# Revised Design Review Recommendation

March 19th, 2013

505 Madison St is a 36 story commercial office building with street level retail with seven levels of below grade parking. It is located on the west side of the block bounded by 5th Avenue, Madison Street, Marion Street and 6th Avenue.

DEPARTURE DIAGRAM 1  
5TH AVE. ELEVATION

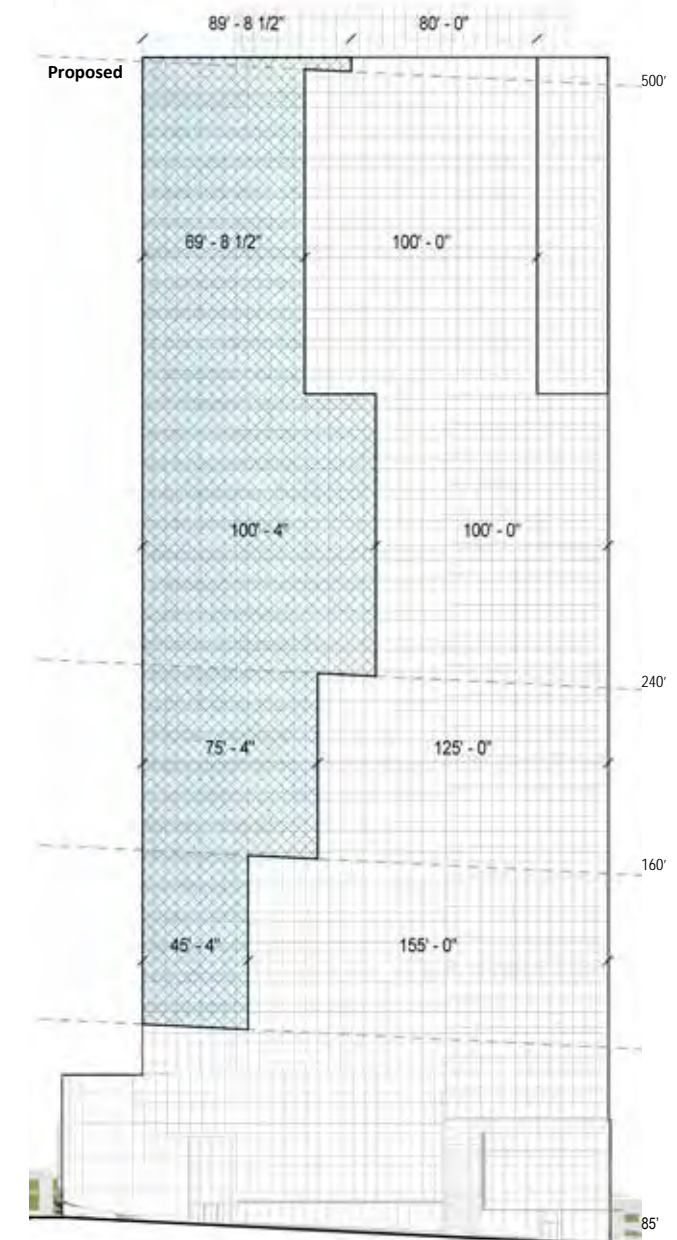
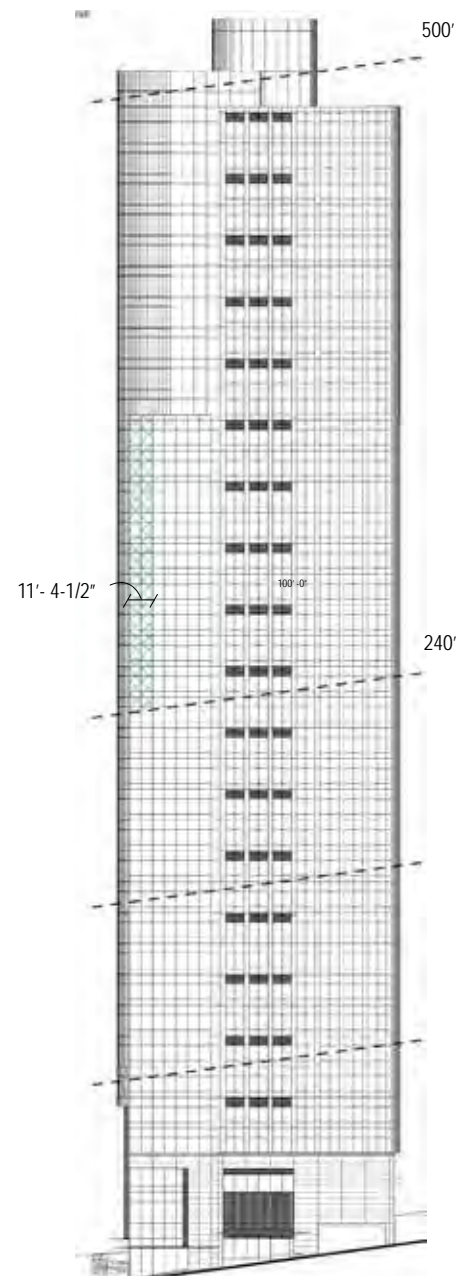
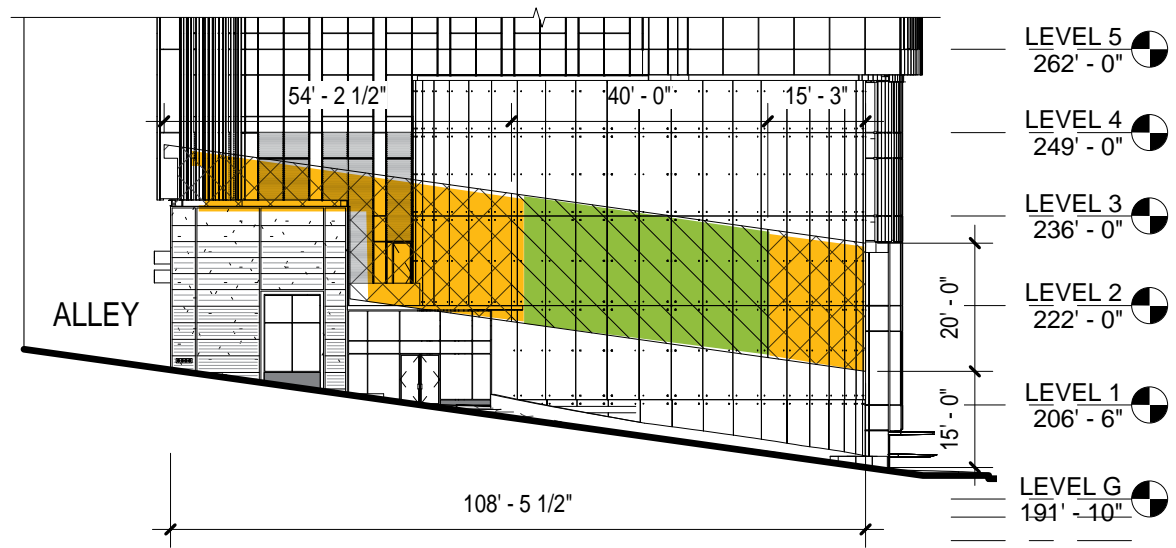
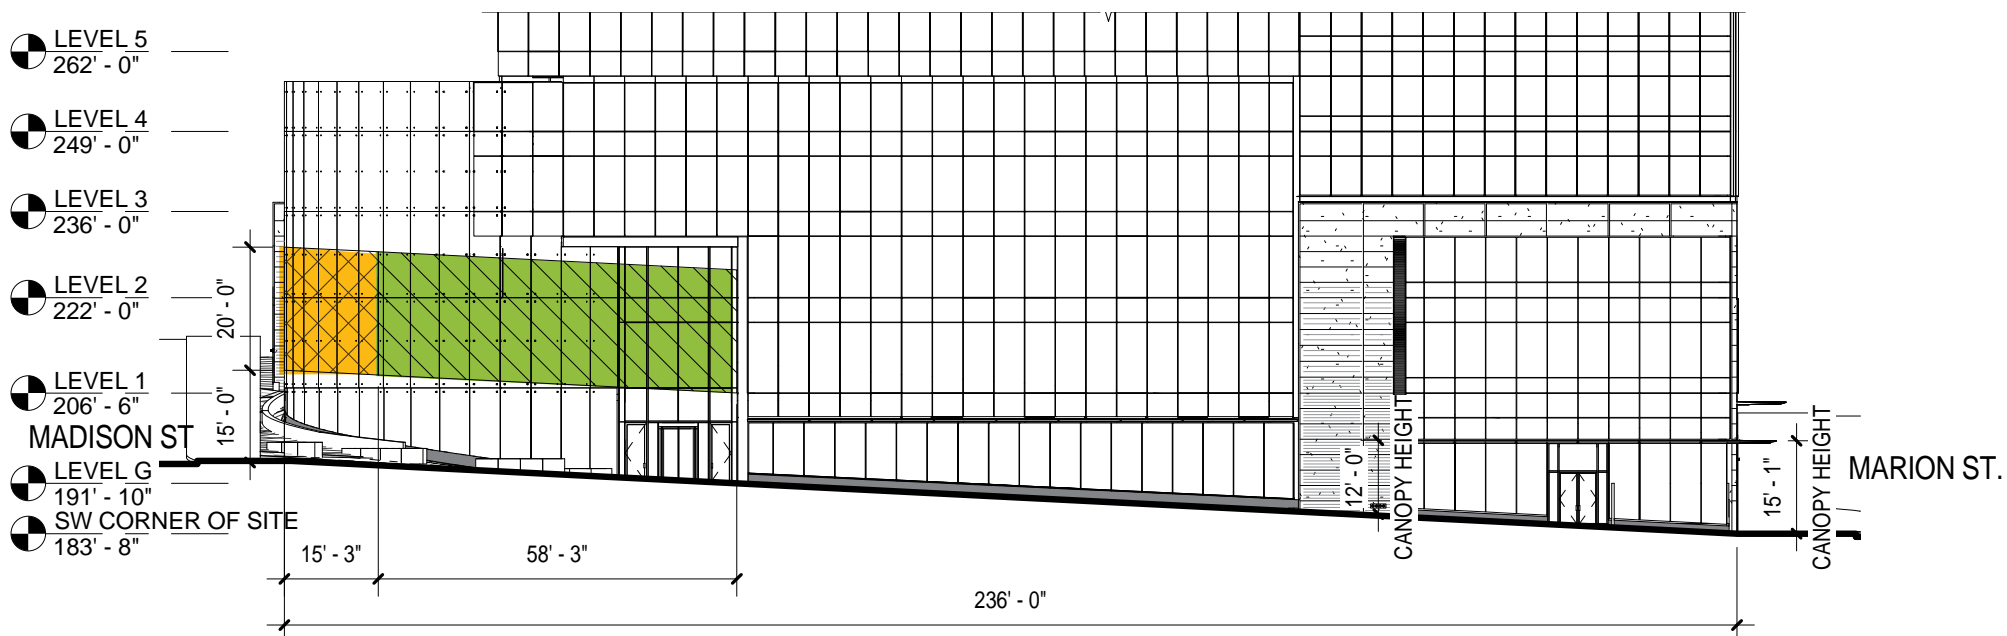
Item #	Development Standard	Requirement	Departure Amount Requested	Rationale	Downtown Design Guidelines Enhancement
1	SMC 23.49.056.B FAÇADE SETBACK LIMITS	Both Madison and 5th Avenue require property line facades. Maximum façade setback between 15' and 35' above grade to be between 2' and 10' from property line and no wider than 20 feet.  No portion of façade between 15' and 35' above sidewalk shall be set back more than 10 feet.	Along 5th Avenue, at the rotunda, one section of the facade measuring 58'-3" long is setback between 2' and 10' beyond the new sidewalk line. Since the maximum permitted setback length is 20', a departure for an additional 38'-3" is requested. A second section of the facade measuring 15'-3" long is setback more than 10' beyond the new sidewalk line. A departure is requested to permit this portion of the facade measuring 15'-3" long to be setback more than 10' beyond the sidewalk line.  Along Madison Street, one section of the facade at the rotunda measuring 40' long is setback between 6' and 10' beyond the property line. Since the maximum permitted setback length is 20', a departure for an additional 20' is requested. A second section of the facade at the corner of 5th and Madison measuring 15'-3" is setback more than 10' beyond the property line. A departure is requested to permit this portion of the facade to be setback more than 10' beyond the property line. A third section of the facade at the retail entry measuring 54' - 2 1/2" long is setback more than 10' beyond the property line. A departure is requested to permit this portion of the facade to be setback more than 10' beyond the property line.	The design sets the north façade back from Madison Street and 5th Avenue to allow for public open space at the north end of the site. This open space is designed to be a public amenity that extends from the small plaza off the café on Madison down the hill in the form of a curved planter to the planting areas, benches and expanded curb bulb at the corner of 5th and Madison.	B-2 Create a transition in bulk and scale: Rotunda form at the building podium continues the curved form of the tower down to the building base at street level and reinforces the prime corner of 5th and Madison.  D-1 Provide inviting and useable open space: The facade along Madison and 5th Avenue is set back from property line beyond 10 feet to create public open space. This includes a small plaza at the cafe at the top of Madison St to the open space with benches and landscaping at the corner of 5th and Madison.

2	SMC 23.49.058 UPPER LEVEL DEVELOPMENT STANDARDS - MAXIMUM FAÇADE LENGTH	Different maximum façade lengths apply for facades at various elevations per chart 23.49.058A	Tower exceeds maximum façade lengths by the following along 5th Ave: 45'-4" between elevations 86' to 160' from level 6 through level 11 75'-4" between elevations 161' to 240' from level 12 through level 17 100'-4" between elevations 241' and 500' from level 18 through level 27 69'-8 1/8" between elevations 241' and 500' from level 28 through level 36 89'-8 1/2" above elevation 500' at the rooftop screenwall  Tower exceeds maximum façade length by the following along Marion Street: 11' - 4 1/4' between elevations 241' and 500' from level 18 through level 27	The office tower is located within 15 feet of the street property line and situated towards the south end of the site to maximize solar access to the Nakamura Courthouse lawn as well as 5th Avenue. The project design also utilizes a curved tower within 15 feet of the street property line for a more slender visual appearance and to yield more light and air at the corners of the blocks which are close to adjacent towers.	A-1 Respond to the Physical Environment: Curved tower facade enables and placement at south end of site maximizes solar access to courthouse lawn and 5th Avenue A-2 Enhance the skyline: Curved west facade promotes visual interest and variety in an area of downtown with rectilinear shaped adjacent towers B-4 Design a well proportioned and unified building Curved facade of tower integrates with curved form at podium and opens the building at the street corner
